Moreland City Council

# **COUNCIL AGENDA**

**WEDNESDAY 28 AUGUST 2019**

# DCF68/19 15 UNION STREET BRUNSWICK - PLANNING PERMIT APPLICATION MPS/2018/601 (D19/271712)

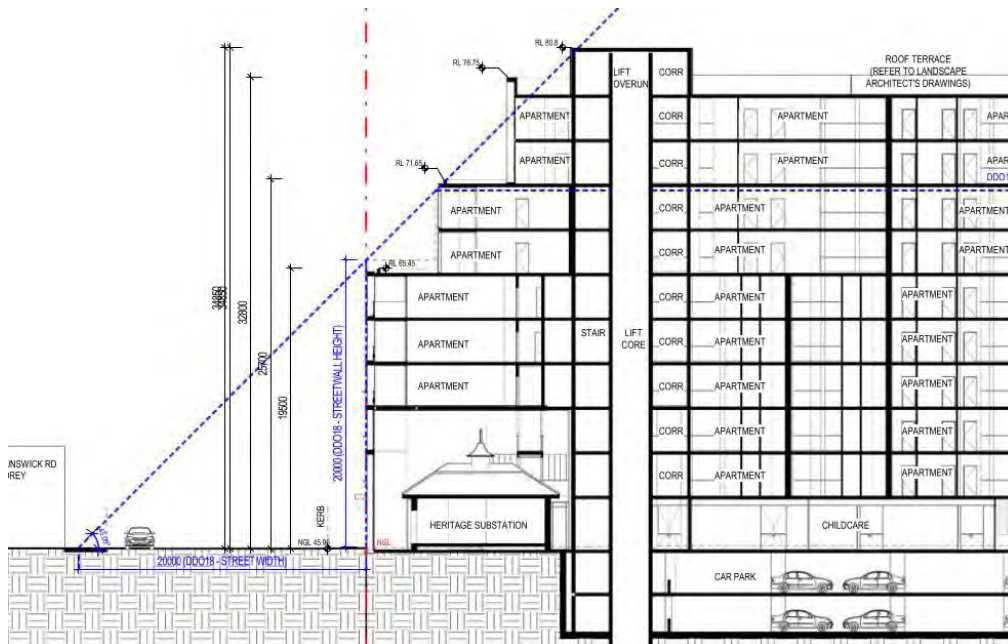
Mr Lewis noted that the proposed enclosure of the substation is inconsistent with Article 8 (Setting) of the ICOMOS Burra Charter which states that conservation requires an 'appropriate setting'. Nigel considers the enclosing of the substation behind glazing will give it a 'ghost like' presence within Brunswick Road, particularly as this façade will likely require some form of treatment due to its northern orientation which will likely reduce the transparency of the glass.

Mr Lewis also comments on the architectural treatment of the façade forward of the substation noting that the grid pattern is introduced at the third level which will partially obscure the roof of the substation. Mr Lewis also believes that simply removing the façade would still not result in an acceptable outcome. He is of the view that levels above the building would not be consistent with the Clause 22.06 of the Moreland Planning Scheme which seeks to ensure that additions to contributory places are 'visually recessive and not dominate the heritage place.'

Mr Lewis concludes that the substation should not be enclosed or built over and the substation 'allotment' be retained with at least 5 metres behind it. He recommends building heights no greater than 11 metres on the 3 boundaries with the substation allotment.

For these reasons the way in which the substation has been retained should not be supported. Due to the uncertainty of how an alternative design solution may be resolved, it is difficult to require changes through conditions.

Figure 2.

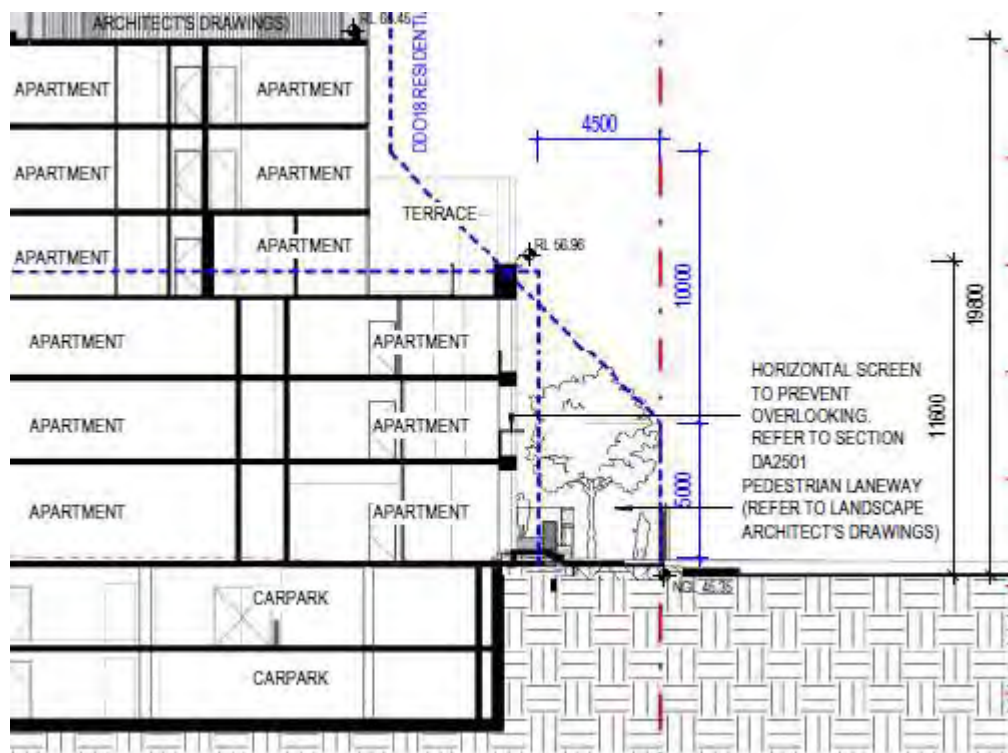
VCAT found that the proposed interface to the east was generally acceptable noting that the setbacks met Clause 22.07 and DDO18 preferred setbacks except for an encroachment at the fourth level.

The amended plans increase the setback of this level from 5.4 metres to 10.5 metres, as shown in Figure 2 below, ensuring compliance with the DDO18 preferred setback at this residential interface. A minor encroachment remains at level 3 however, this will not have an unreasonable impact on the amenity of the property at 180 Brunswick Road.

Figure 3: Extract from Town Planning Drawing - TP-25 (Section A), showing the minor encroachments into the indicative sightline prescribed under DDO18.

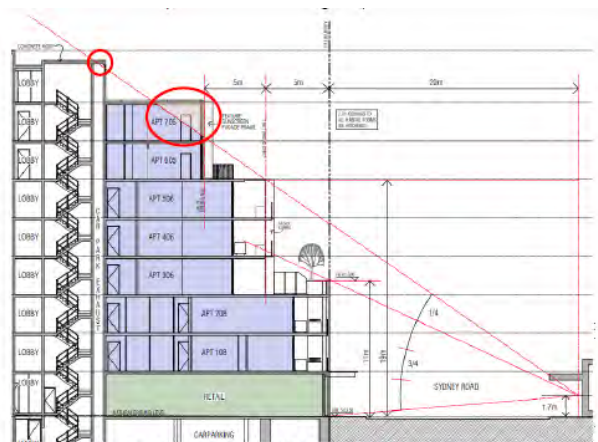
The DDO18 states that the upper levels should occupy no more than one quarter of the vertical angle defined by the whole building in the view from an eye-level of 1.7 metres on the opposite side of Sydney Road.

The proposal in its current form does not achieve this (as demonstrated in the circled area below).
